# Access Compliance Report

## Public Rights-of-Way

Intersection ID: 11295	Main Street: AVENTIDE_LN	Cross Street: CHANTRESS_LN	Location: SE
ADA ID: F82F9557C687	Ramp Type: Perp	Initial Pass/Fail: Fail	Overall Compliance: No
Severity Score: 46.25			
Codes/Mitigation Info/Possible Solution		Field Measurements/Component Compliance

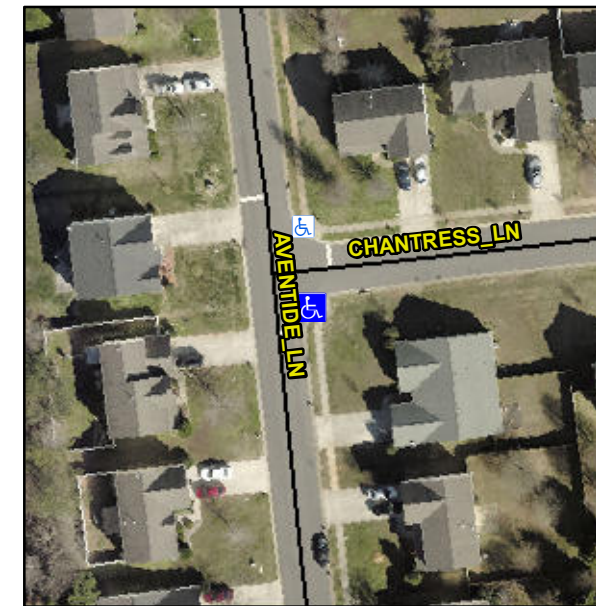
**Not Found, R304.5.1, R304.2.2, R304.5.3, R302.7**

Compliance	Description	Data	Compliance	Description	Data
N/A	Ramp Length (in)	48.0	No	Ramp Slope (%)	9.7
No	Ramp Width (in)	33.5	No	Ramp XSlope (%)	3.2
N/A	Flare Type LT	N/A	N/A	Flare Type RT	N/A
N/A	Flare Slope LT (%)	N/A	N/A	Flare Slope RT (%)	N/A
N/A	Flare Traversable LT?	N/A	N/A	Flare Traversable RT?	N/A
N/A	Landing Length (in)	N/A	N/A	DWS Provided?	N/A
N/A	Landing Width (in)	N/A	N/A	DWS Contrast?	N/A
N/A	Landing Slope (%)	N/A	N/A	DWS Length (in)	N/A
N/A	Landing X Slope (%)	N/A	N/A	DWS Full Width?	N/A
N/A	Landing Curb? (Y/N)	N/A	N/A	DWS Offset (in)	N/A
N/A	Shared Landing?	N/A			
N/A	Gutter Ponding?	N/A	N/A	Gutter Slope (%)	N/A
N/A	Gutter Lip Ht (in)	N/A	N/A	Gutter X Slope (%)	N/A
N/A	Painted X Walk1?	No	N/A	Painted X Walk2?	N/A
	X Walk 1 Direction	To N		X Walk 2 Direction	N/A
N/A	X Walk 1 Width (in)	N/A	N/A	X Walk 2 Width (in)	N/A
	X Walk 1 Slope (%)	1.3		X Walk 2 Slope (%)	N/A
	X Walk 1 X Slope (%)	0.6		X Walk 2 X Slope (%)	N/A

N/A	Ramp inside XWalk1?	N/A	N/A	Ramp inside XWalk2?	N/A
	Road Slope (%)	N/A	N/A	Clear Space?	N/A
	Road X Slope (%)	N/A	N/A	Clear Space to XWalk (in)	N/A
N/A	Any Obstructions?	N/A	N/A	Storm Grate/Utility Hazard?	N/A
	Obstruction Type			Storm Grate/Utility Type	
		N/A			N/A
		No		Surface Condition? (G/P)	Poor

**Remove & Replace Entire Ramp.**
